URBAN DESIGN COMMISSION APPLICATION

Address (list all addresses on the project site): 4725 Tradewinds Parkway
Title: Synbiotic Health

RE: 4725 Tradewinds Parkway
Urban Design Submittal / Upgrade

SYNBIOTIC
INTERIOR BUILD-OUT
4725 TRADEWINDS PARKWAY
MADISON, WI 53718

WEST
ELEVATION

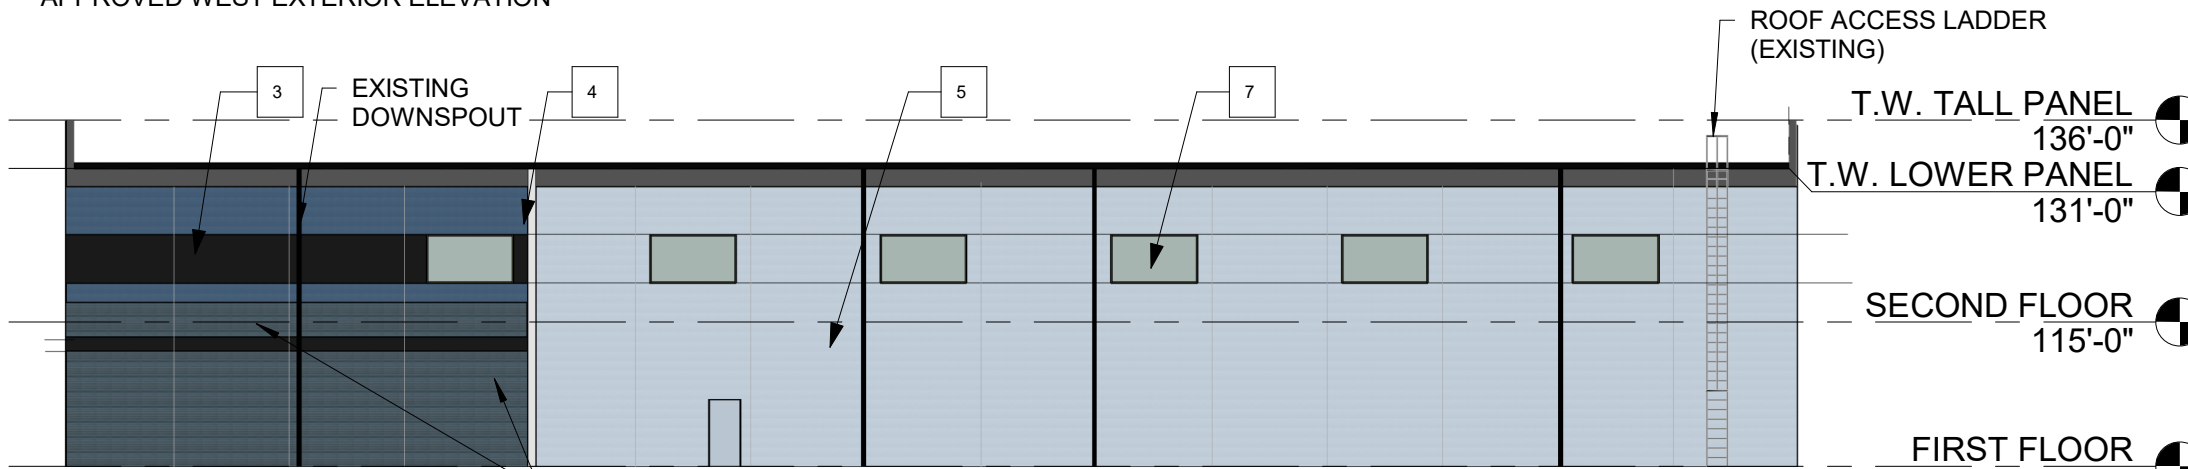
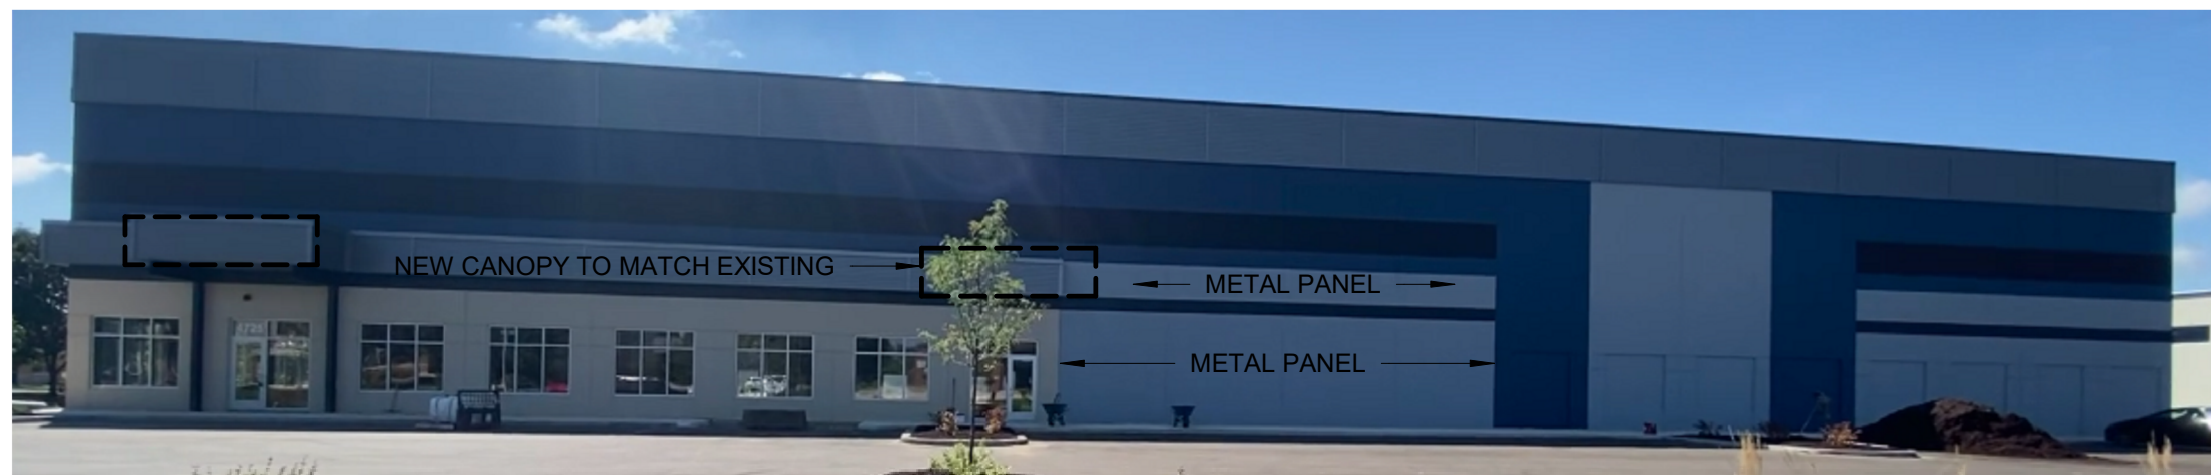
PROPOSED WEST EXTERIOR ELEVATION
ADD METAL PANEL TO WALL AND COVER THE FUTURE FRAMED OPENINGS

NORTH ELEVATION

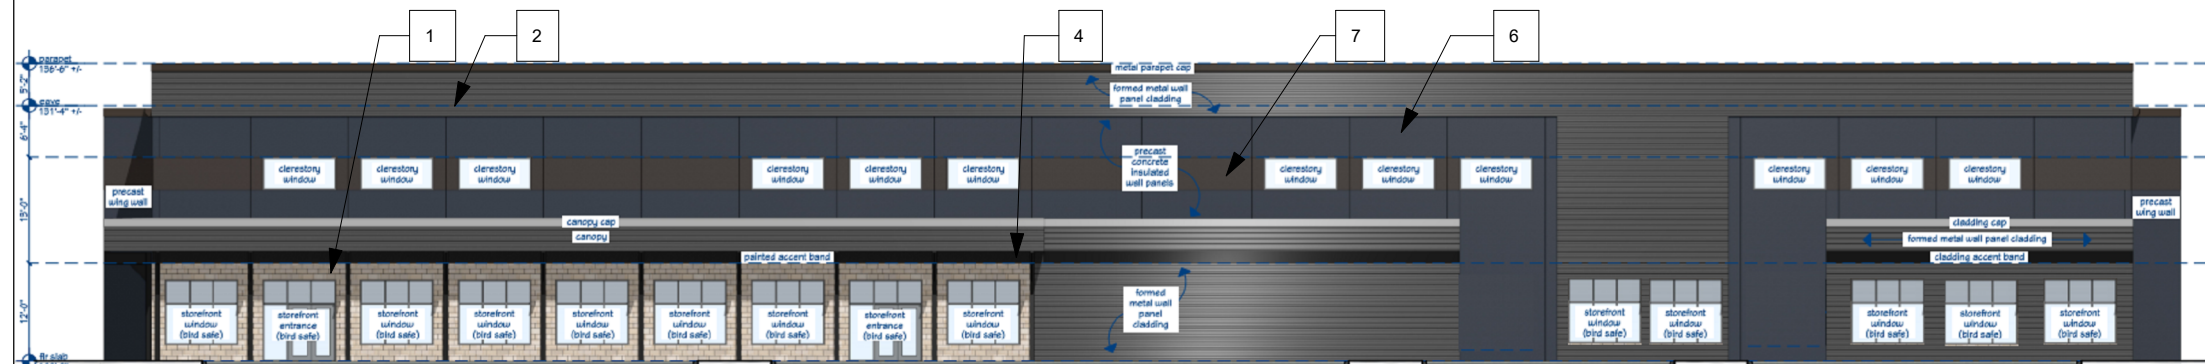
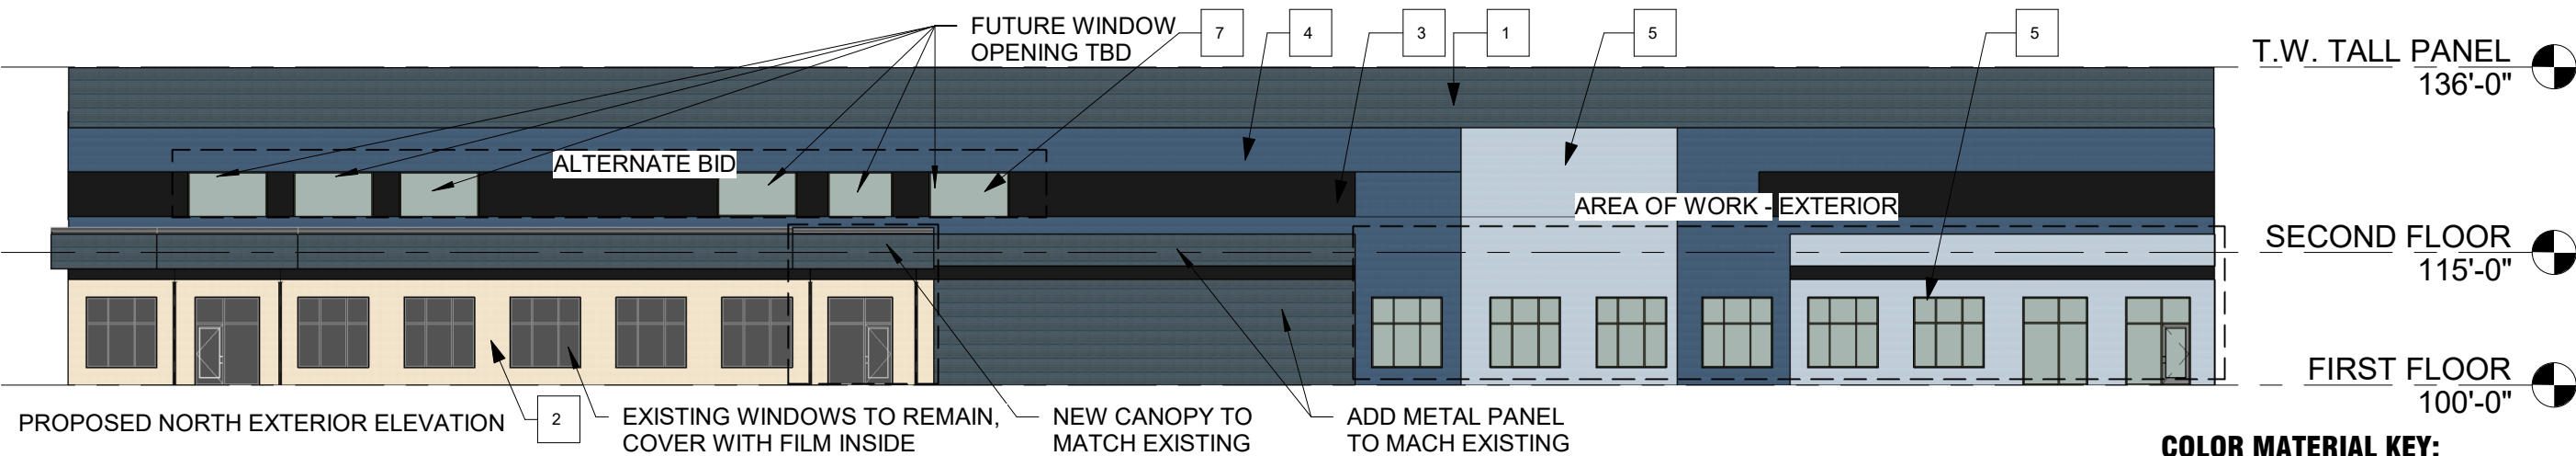
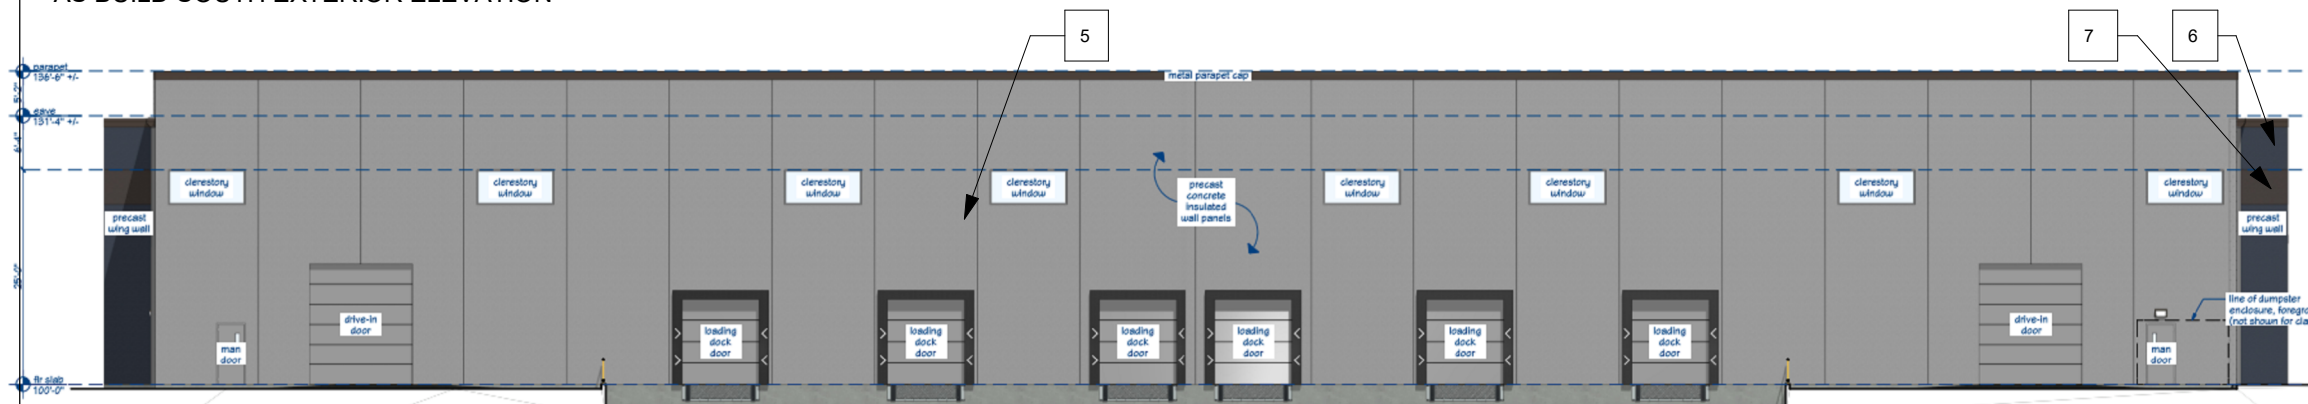
EXISTING WINDOWS TO REMAIN, COVER WITH FILM INSIDE
NEW CANOPY TO MATCH EXISTING
ADD METAL PANEL TO MACH EXISTING

SOUTH
ELEVATION

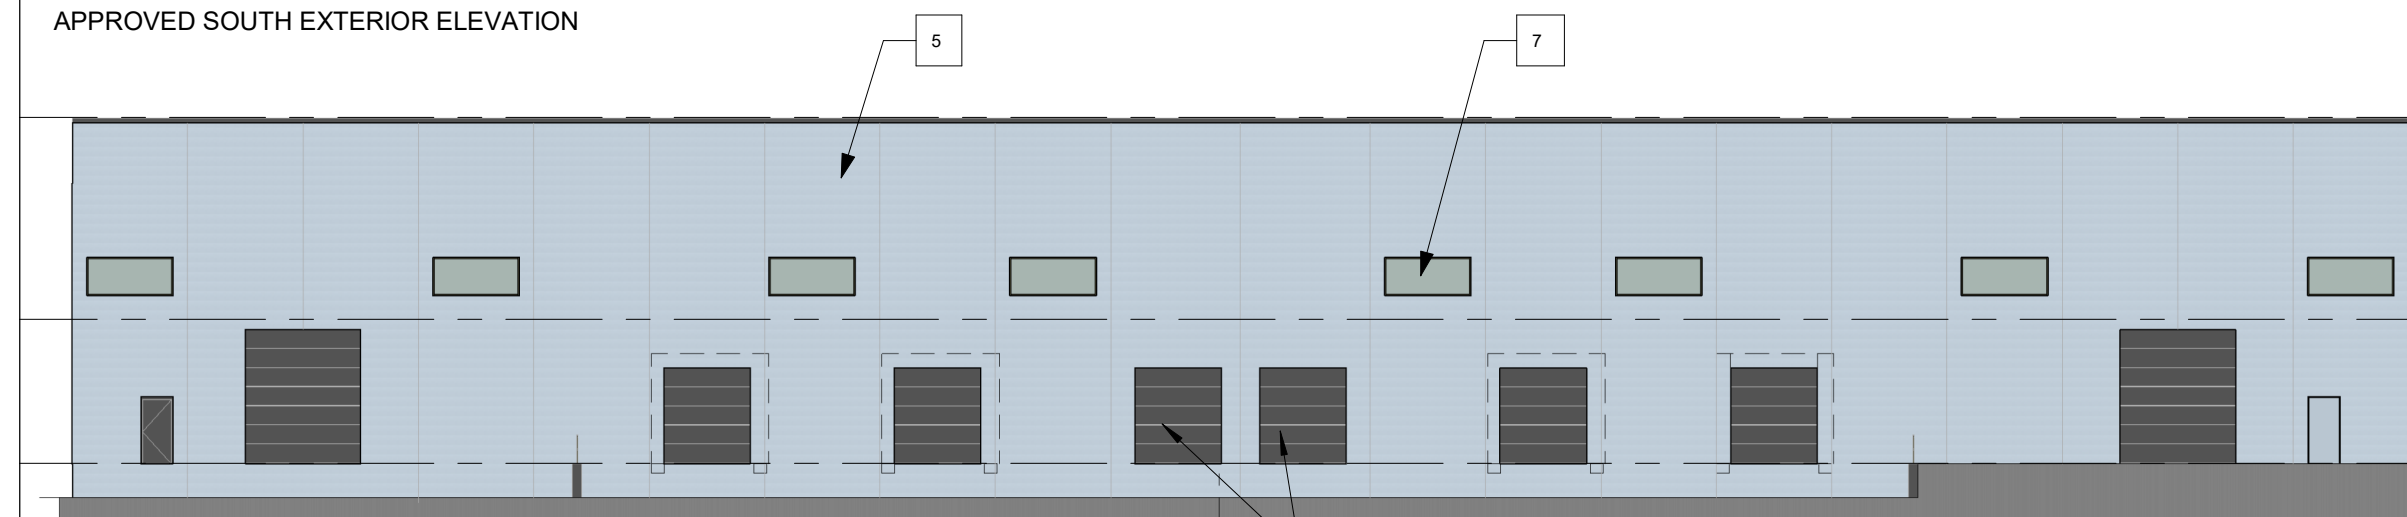
PAINT EXISTING DOOR BLACK TO MATCH COLOR DOCK DOORS
